ADDENDUM NO. 1

DATE: October 23, 2018
FROM: Village of Villa Park Public Works Department
TO: All Planholders
PROJECT: **Jackson Pond Overflow**

JACKSON POND OVERFLOW PROJECT

ELECTRICAL DETAILS

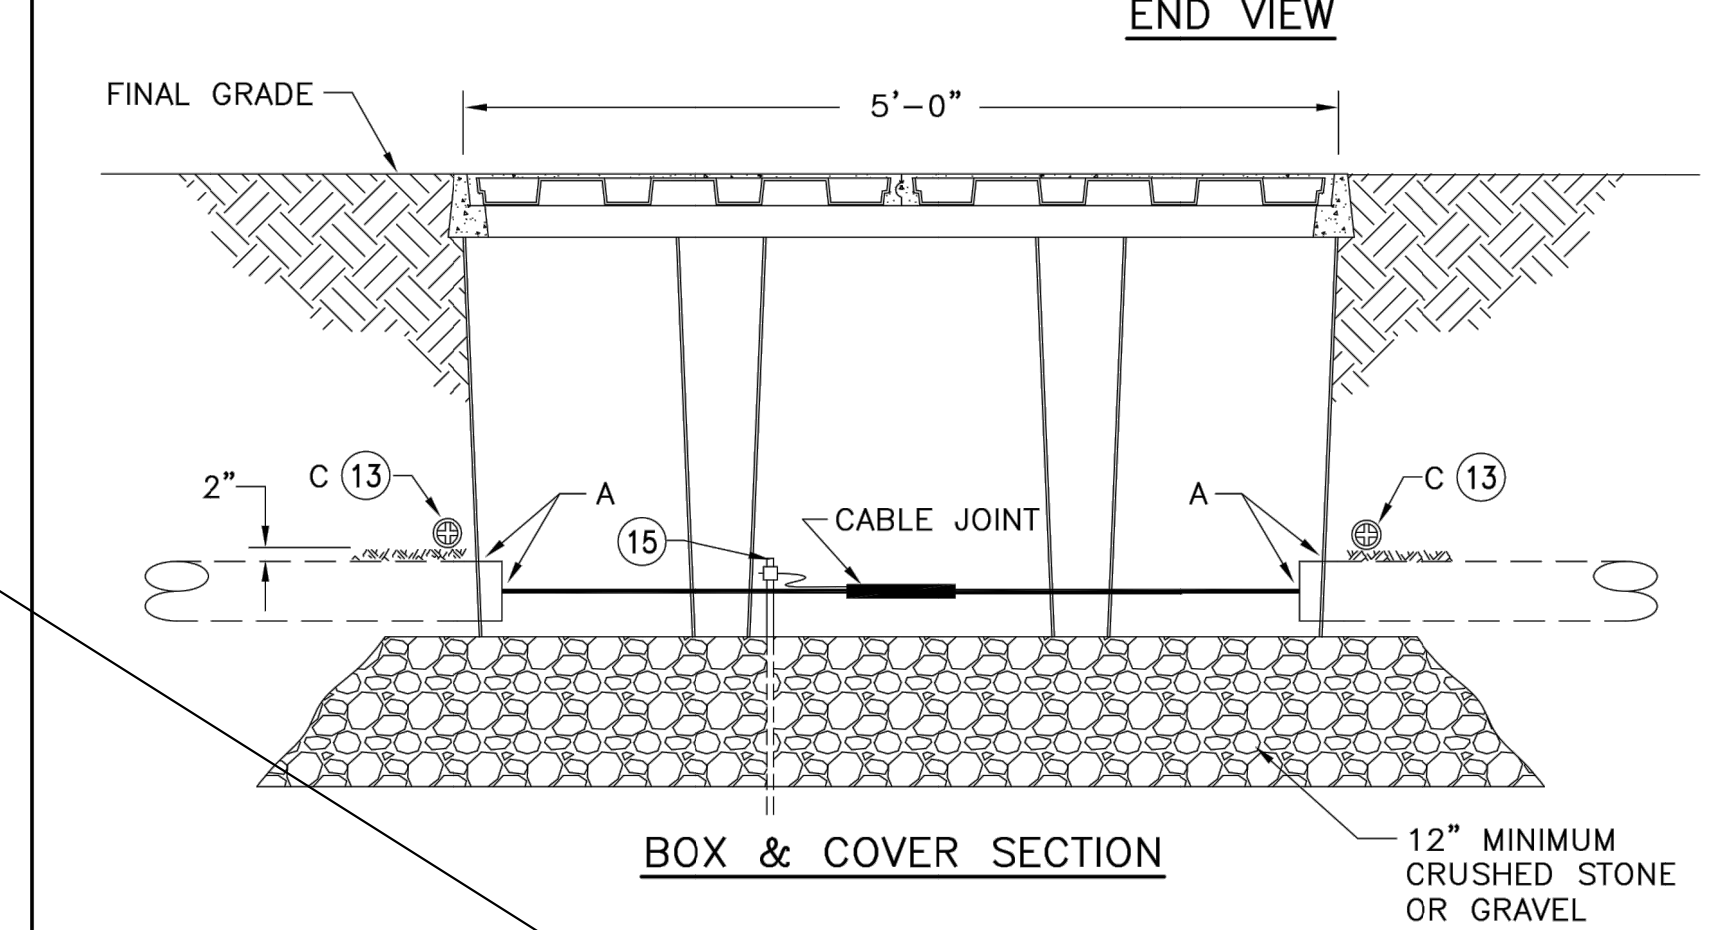
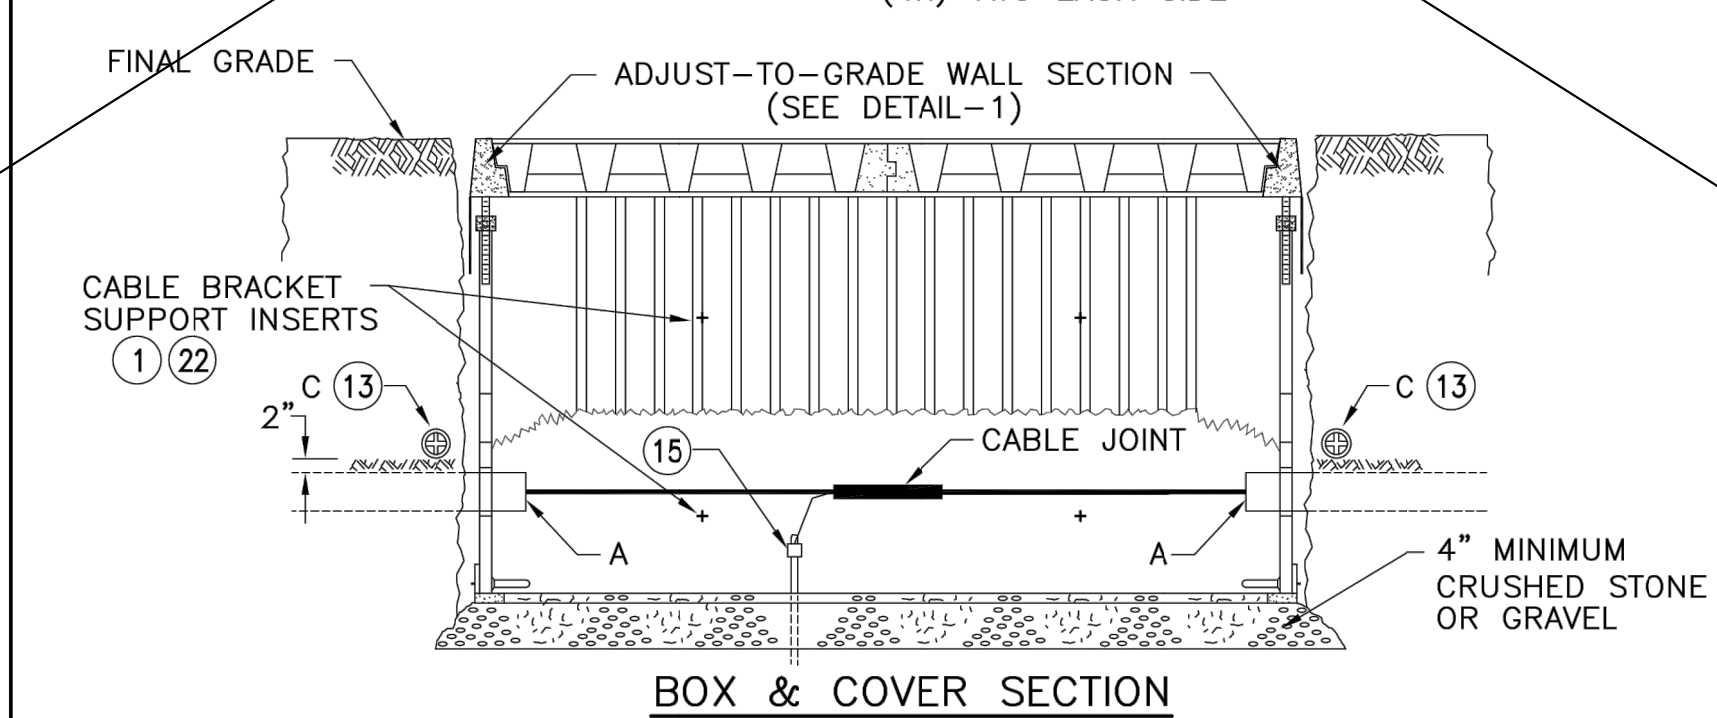
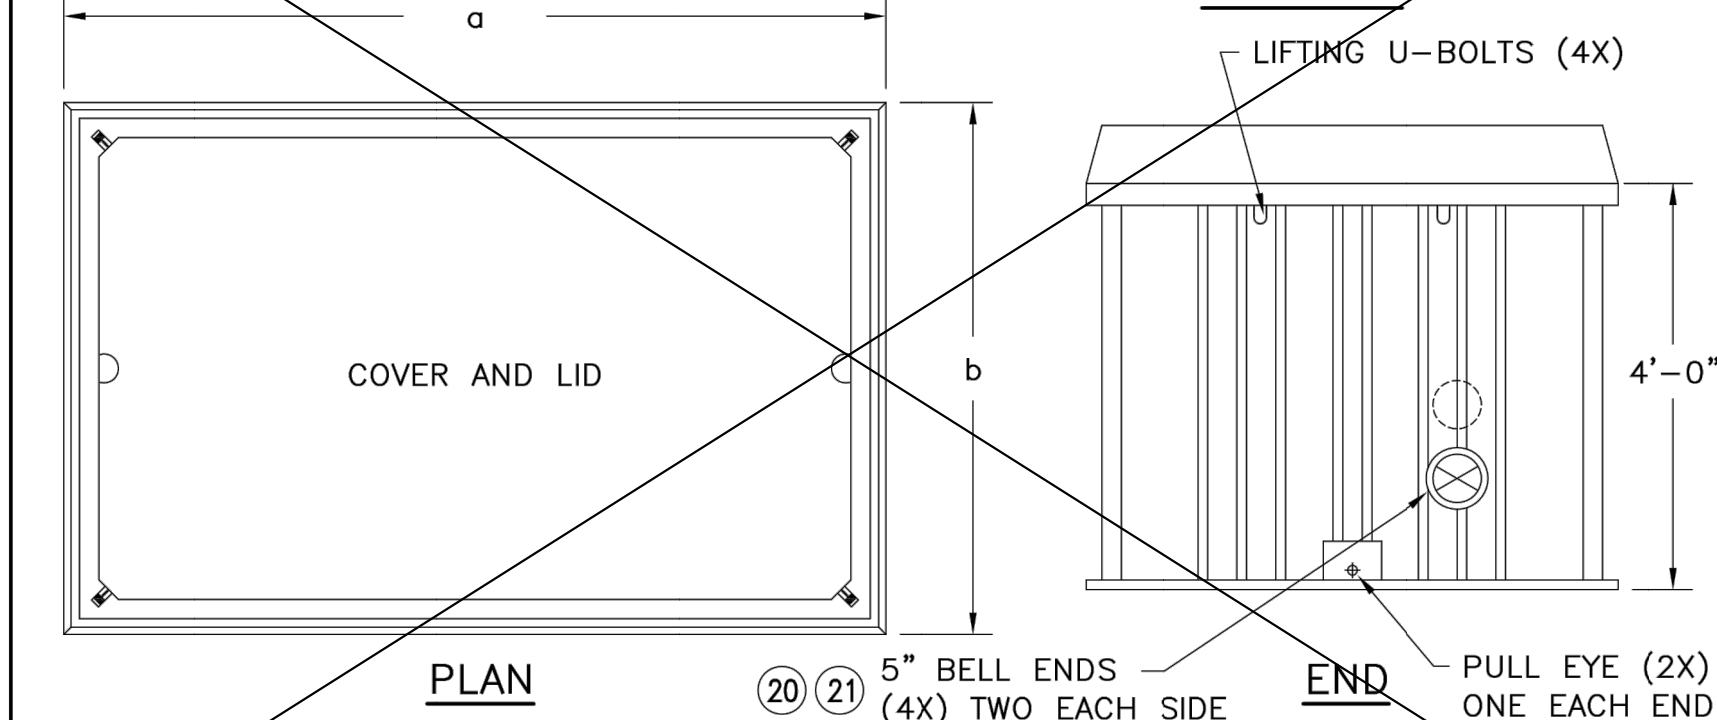
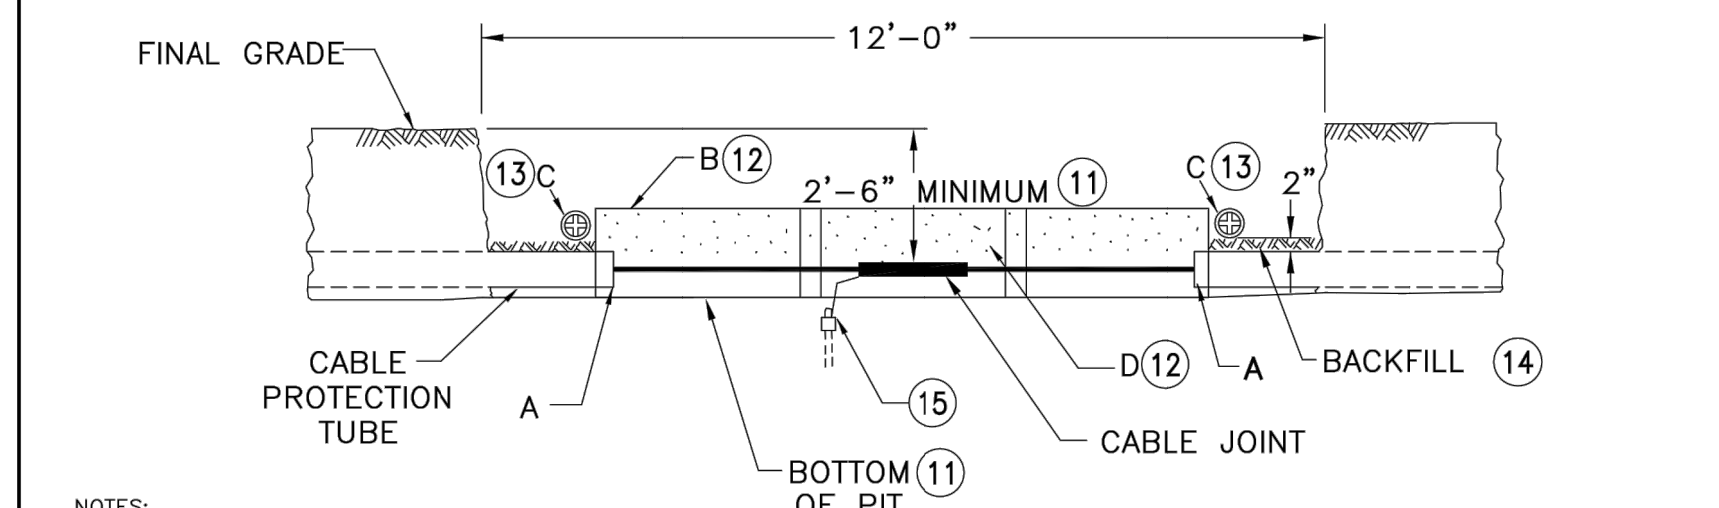
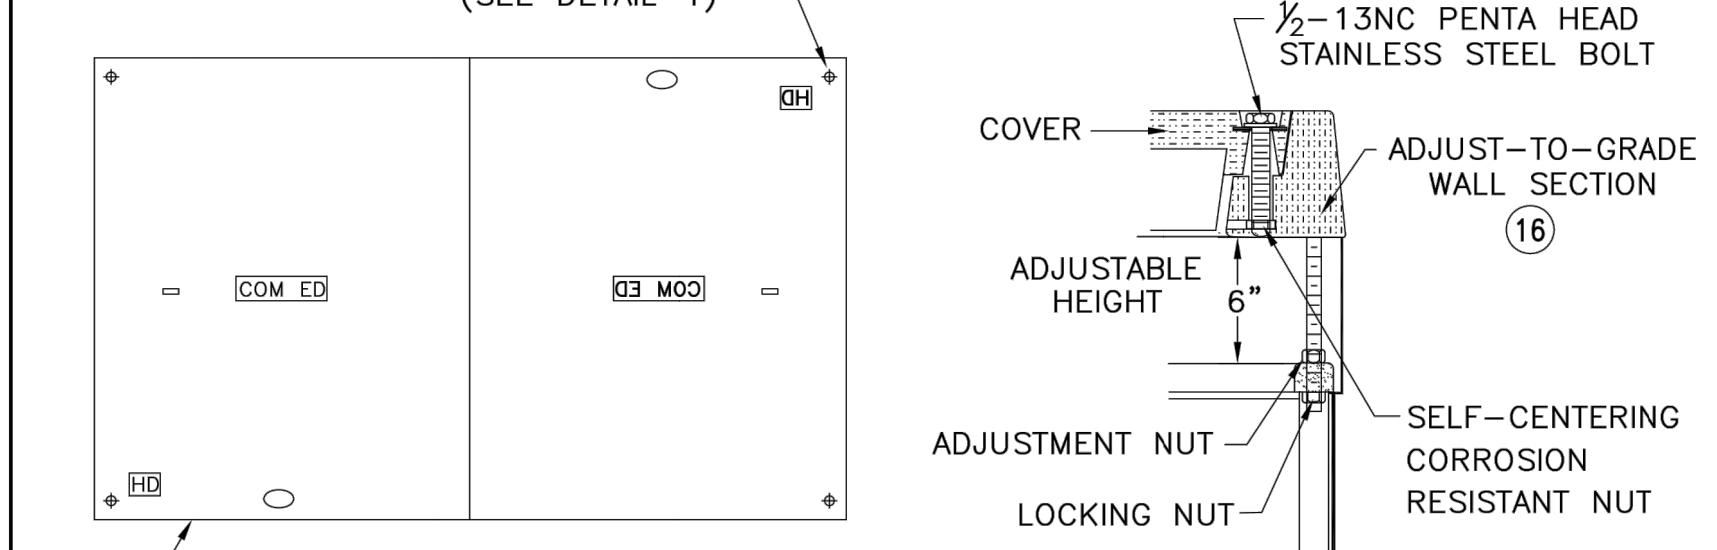
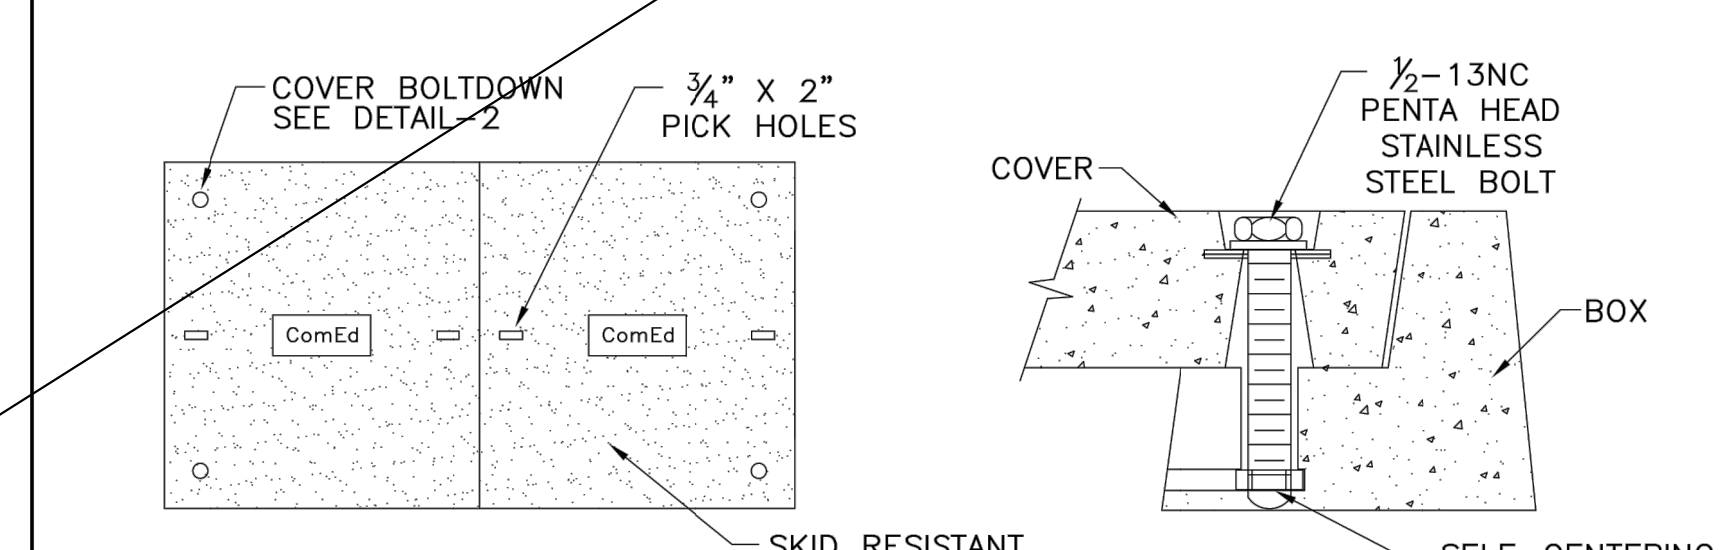
Replace Page 34 of the Plans with the attachment included in this addendum. The revision made was the removal of the ComEd Primary Splice Box Details. The revisions are crossed out on the plan sheet.
